Interactive comment on "Seismic imaging of dyke swarms within the Sorgenfrei Tornquist Zone (Sweden) and implications for thermal energy storage" by Alireza Malehmir et al.

Alireza Malehmir et al.

Received and published: 13 November 2018

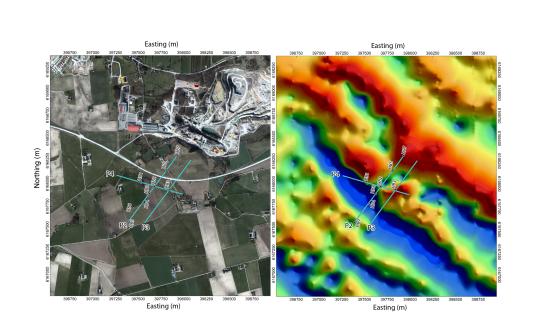
(Anonymous Referee #1) Page 19 line 8: "a pattern for the groundwater flow towards SE (Fig. 14b) and an orientation consistent with the directions of the dykes and major structures in the area (Fig. 1a). Reflections (R1-R4) greatly match this orientation". I would argue that contour lines presented on figure 14b are more complex than described in the statement above which appears a bit oversimplified. Please provide a more precise description and location (i.e. between R3 and R4 near P2 and P3?). Also, why are lines of water table continuous across reflection R1, R2, R3, and R4 if these reflections are water barriers?

(Authors) You are correct. It might be that the down faulting system we referred to in the picture appended here makes the water flow more complicated in the region where R3 and R4 located. It is consistent to be on the same orientation as P2. We have revised the text accordingly. Thanks for noting this valuable information.
